Application Serial No: 10/814,360

In reply to Office Action of 12 September 2005

AMENDMENTS TO THE DRAWINGS

REMARKS / ARGUMENTS

Annotated sheet Showing Changes

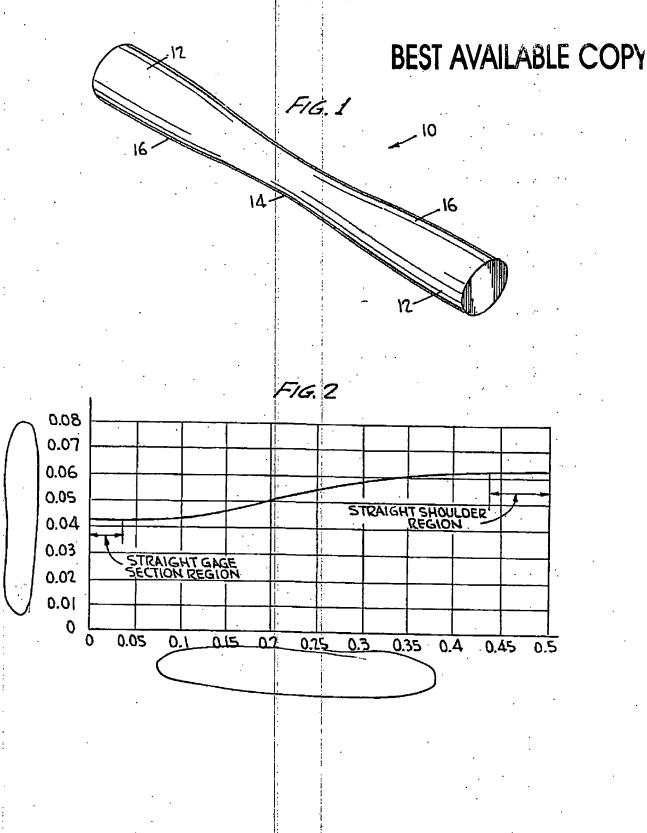
The Examiner objected that Figure 2 of the drawings lacks labeling for the x and y axis. She required appropriate correction including all of the figures appearing on the sheet. She stated that each drawing sheet submitted after the filing date of an application must be labeled in the top margin as either "Replacement Sheet" or "New Sheet" pursuant to 37 CFR 1.121(d).

Please replace sheet 1 of the drawings with the attached replacement sheet. The attached replacement sheet includes \mathbf{x} and \mathbf{y} axis captions for FIG. 2.

Applicant has corrected FIG. 2, and a replacement sheet is submitted herewith.
